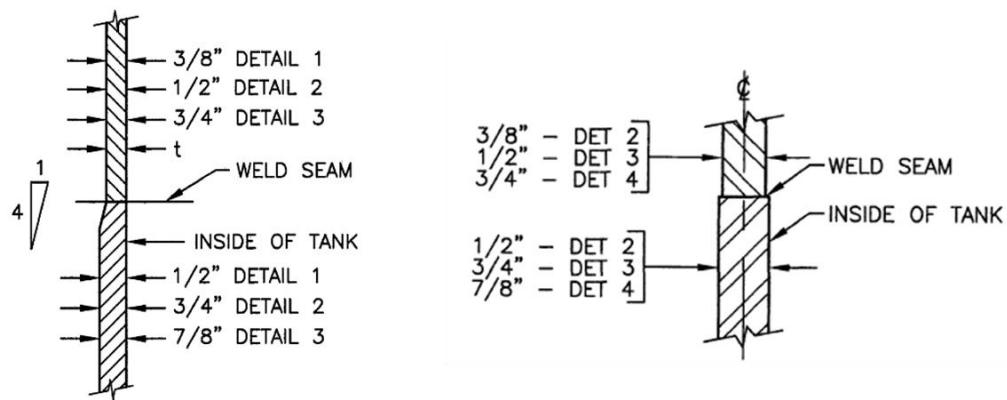
8. Does the mockup DST tank steel need to match the plate size (e.g., do the plate seams need to match per the original design drawings)?

Wall and knuckle configuration should match provided drawing. Half inch floor plate configuration does not need to match design drawings however, weld seams should be typical in nature with 3 to 5 weld seems between the bottom knuckle and tank center.
